Our ref: 24-02315
Date: 30th July 2025

S62A Planning Application - 110-112 East Street, Bedminster, BS3 4EY

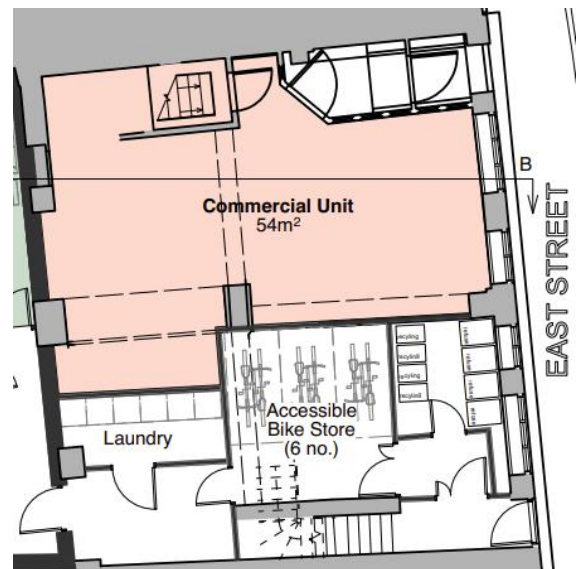
The design and scale of the proposal is not considered to preserve the character of the Conservation Area. This stems from concern that the division of the Commercial Unit and Bin/Bike Storage at the frontage of East Street would have a negative visual impact on the Bedminster Conservation Area.

The bin / bike store to East Street was approved under planning permission ref. 23/00686/F, and has since been built out. It is an established and existing arrangement, and is shown on the existing ground floor plan submitted with the application. The current proposals slightly alter the layout of the bin / bike store to improve circulation, and increase its depth into the unit, but do not change its width, nor materially affect its relationship with the street. On this basis, it is considered that there will be a neutral impact on the Conservation Area, since the area of “inactive” frontage will remain unchanged. Please refer to the existing and proposed ground floor plan extracts below for reference, which show the bin / bike store frontage width unchanged.
